<b>DOCKETED</b>	
<b>Docket Number:</b>	26-OPT-02
<b>Project Title:</b>	Seahawk Battery Energy Storage System
<b>TN #:</b>	270942
<b>Document Title:</b>	Comment letter from Save Our Rural Town
<b>Description:</b>	N/A
<b>Filer:</b>	System
<b>Organization:</b>	Jacqueline Ayer
<b>Submitter Role:</b>	Public
<b>Submission Date:</b>	6/23/2026 1:18:36 PM
<b>Docketed Date:</b>	6/23/2026

Subject: Comments by Save Our Rural Town (SORT) pertaining to the Sequoia Energy Storage 1, LLC BESS development

Reference: California Energy Commission Docket Number 26-OPT-02.

Figure 1. Source and Maximum  $\chi/Q$  locations Modeled by the Developer and the Location of the Maximum  $\chi/Q$  Value When a Different Source Location is Modeled.

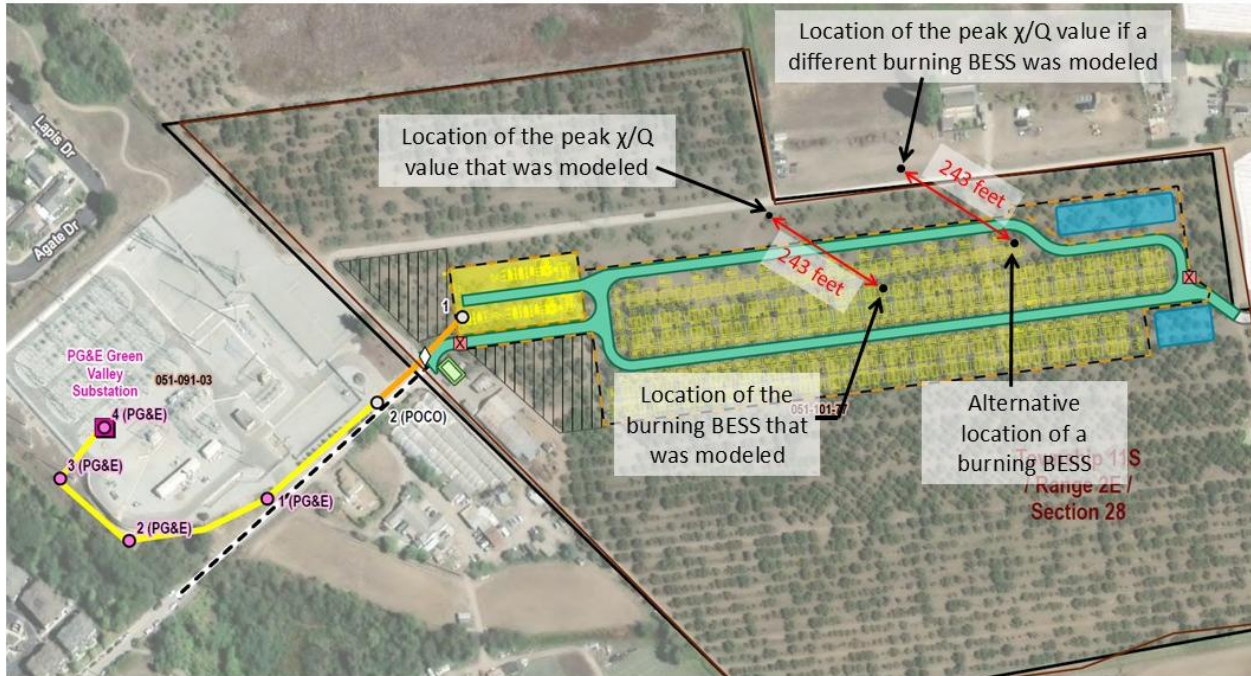
- Another concern is that the location of the BESS fire that the developer modeled appears to have been carefully chosen to ensure that the peak 1-hr  $\chi/Q$  value output from the AERMOD analysis would fall within the project boundary and not coincide with an offsite receptor location. Specifically, page 784 states that the location of the

modeled BESS fire is at UTM coordinates 610711.079 (easting) and 4090031.223 (northing), and page 722 reports that the peak 1-hr  $\chi/Q$  value resulting from the modeled BESS fire location is 1446 and occurs at 610483.87 (easting) and 4090384.64 (northing). This happens to be a location that is just inside the project boundary; it also happens to virtually coincide with the location of the peak 8-hr  $\chi/Q$  value<sup>9</sup>. However, if the developer had chosen a BESS device located further east to model a fire, the 1446 peak  $\chi/Q$  value would be in the front yard of the adjacent residence. This fact is demonstrated in Figure 1 below, and it suggests that the developer's AERMOD analysis does not fully capture potential MEIR locations. This is important, because when the peak  $\chi/Q$  value projected for this alternative location (1446) is reconciled with the developer's assumed HF emission rate (0.2769521 g/s), the projected HF concentration at the front yard of the adjacent residence is 400.5  $\mu\text{g}/\text{m}^3$  which substantially exceeds the 240  $\mu\text{g}/\text{m}^3$  REL threshold for HF. Accordingly, and contrary to what the developer claims on page 843, the AERMOD results show that the ignition of some BESS units will result in unacceptable HF concentrations on adjacent residential properties. This suggests that, at the very least, the developer should be directed to conduct additional AERMOD analyses to ensure MEIR values are properly ascertained.
